**RE: French Drain Removal Update - Response to Comments
C&D Landfill (Permit No. 43-03)
Harnett County Anderson Creek Landfill Facility
Spring Lake, North Carolina**

**ANDERSON CREEK C&D LANDFILL
 FRENCH DRAIN REMOVAL DETAIL**

FIGURE NO. 1
 SCALE: AS SHOWN
 APPROVED: J.A.S.
 DRAWN: K.C.B.

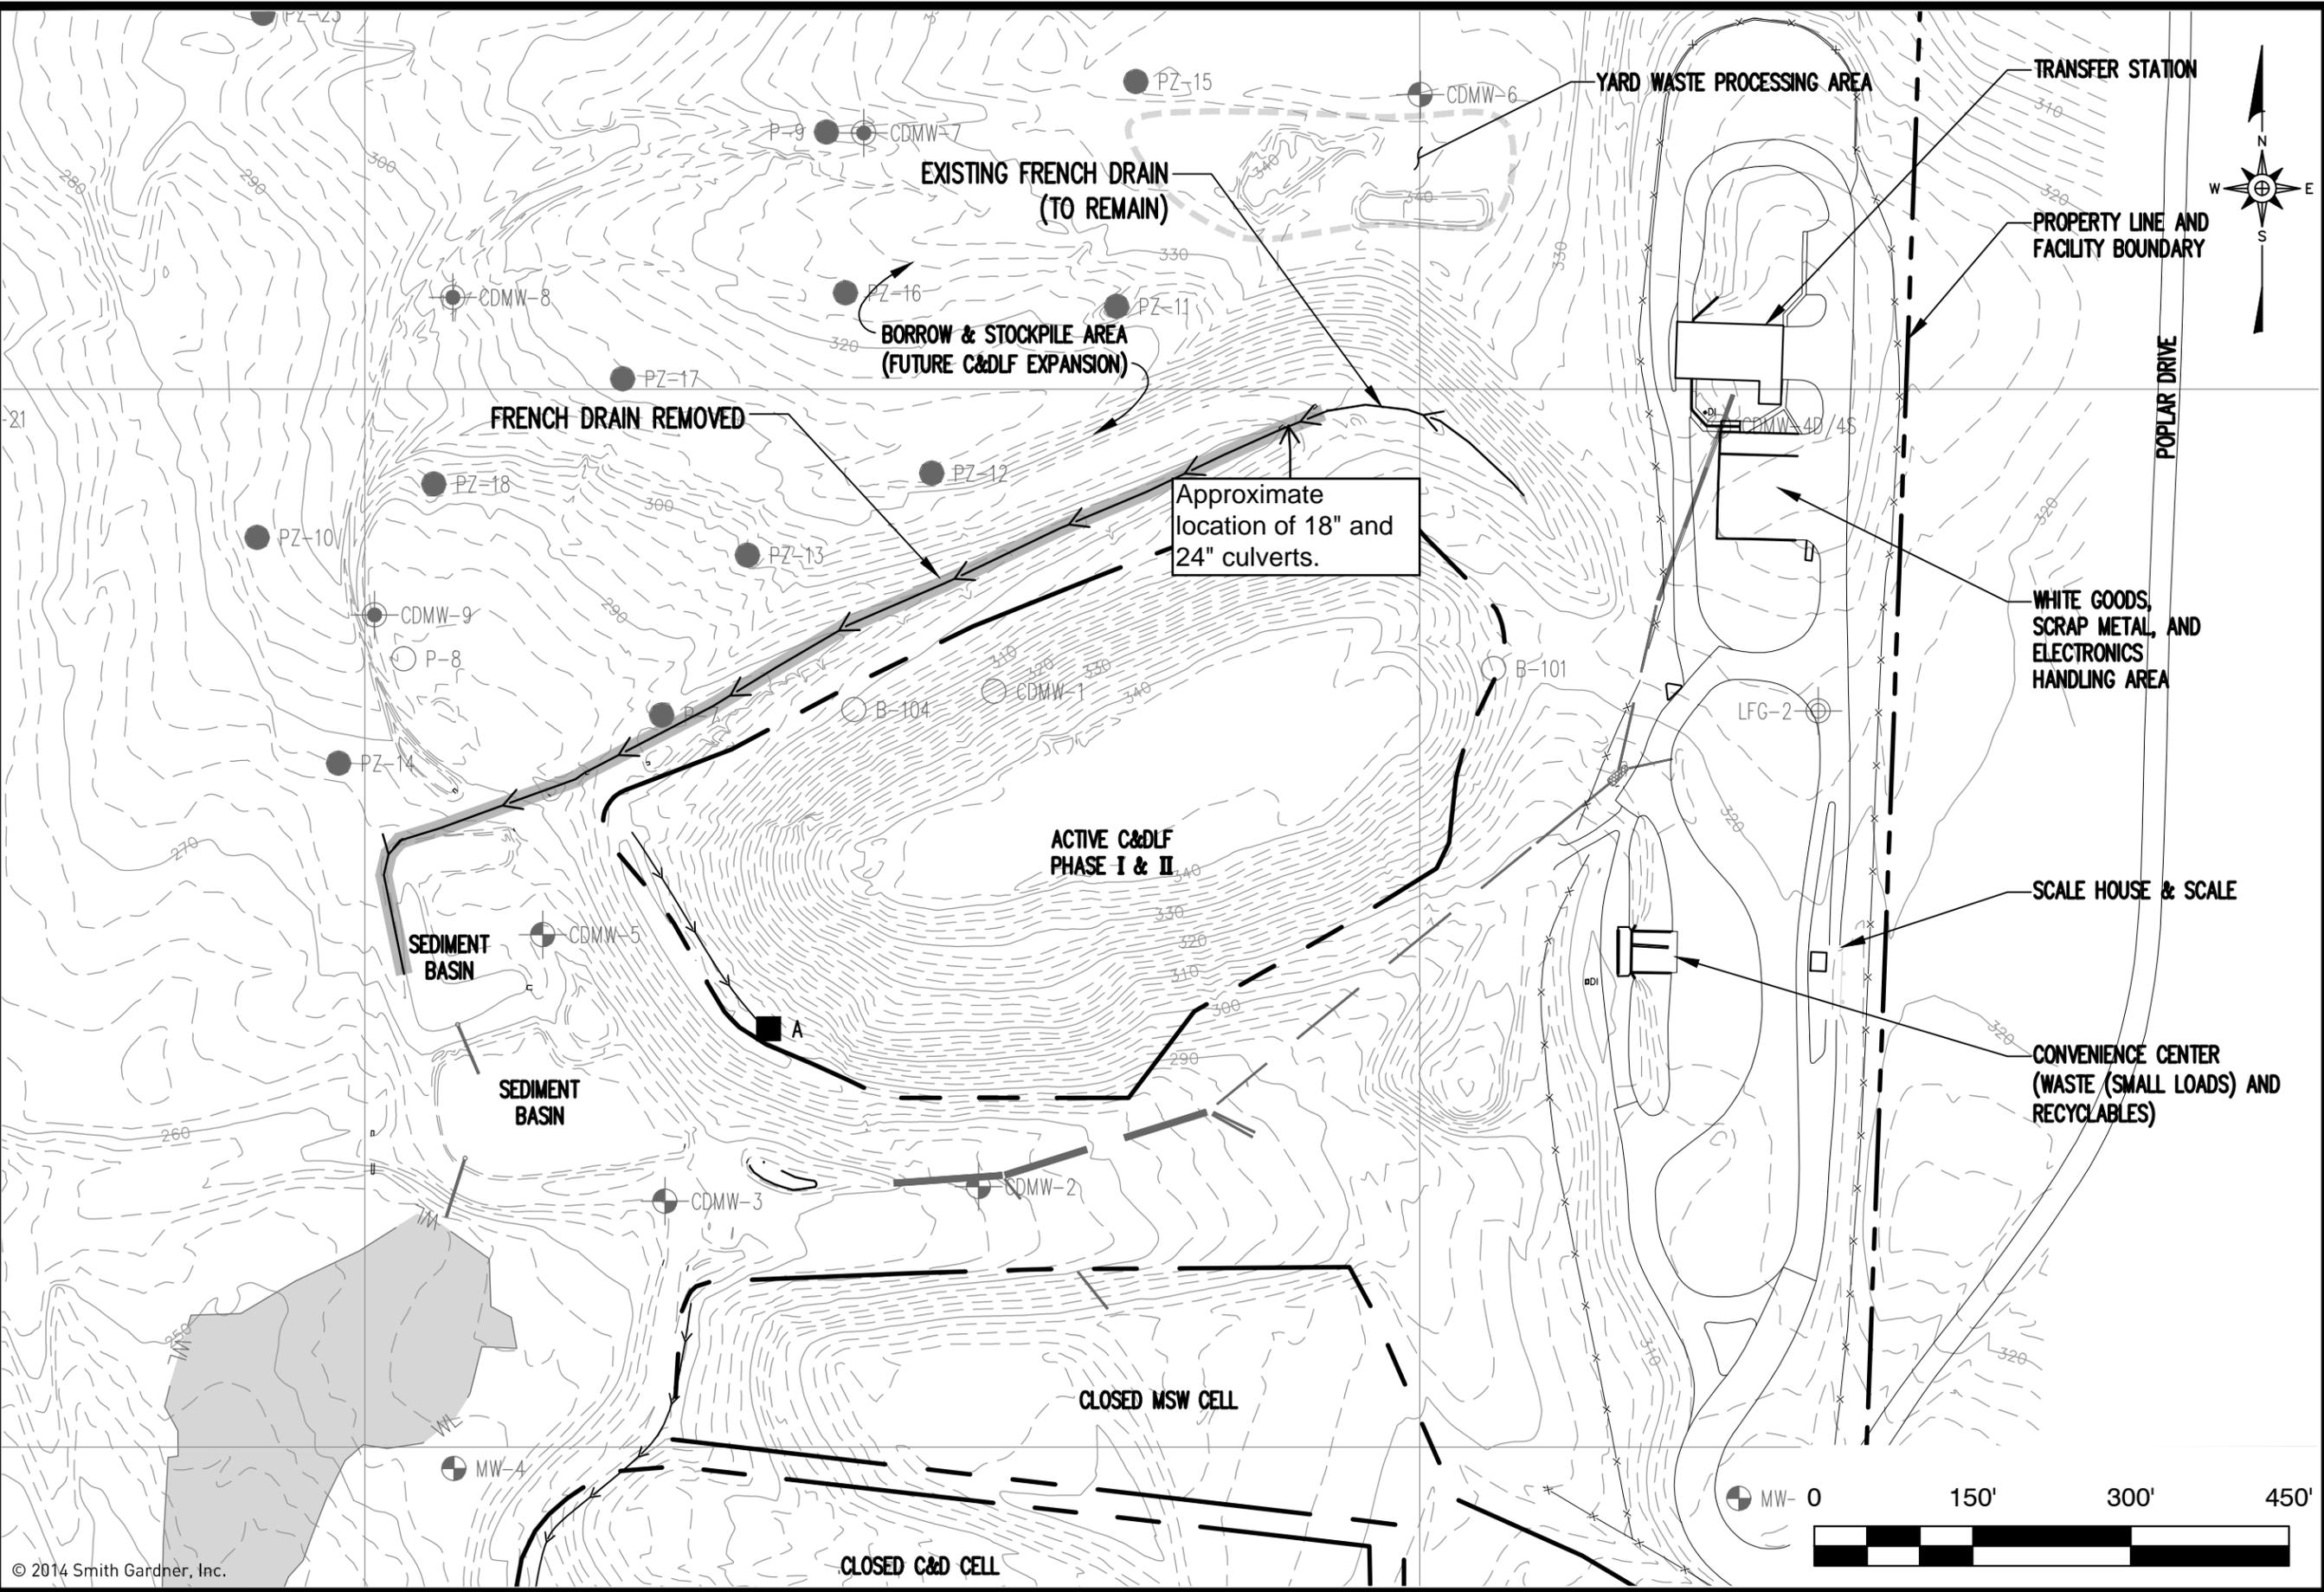
Comment #1: Please describe the size of the drain pipe. Was it perforated and enveloped by granular fill/geotextile? How deep was the drain pipe (below ground surface)?

Response #1: The french drain consisted of a 6-inch diameter pipe and a 4-inch diameter pipe. These pipes were perforated corrugated polyethylene (CPE-Type P). At the location of the old road at the east end of the active C&D landfill, there were two culverts –18-inch and 24-inch diameter, respectively (shown on **Figure 1**). The french drain pipes and two other previously unknown french drains, were found within the culvert piping. All the piping at this location was excavated and the two additional french drains were found to extend only a short distance and stop. These pipes were found to be dry and were removed with the main french drain piping in this area.

Approximately 50 feet of the french drain piping, at the end near the sedimentation basin was surrounded by gravel. The remainder of the french drain system was installed in native soils. Both pipes were covered with geotextile material (“sock”). As stated in our original letter, the original site berm of clayey material was located adjacent to the piping in the area where removal stopped. At this location, the piping was approximately 24 feet below current grade. Near the sedimentation basin, the french drain piping was approximately 5 feet below grade.
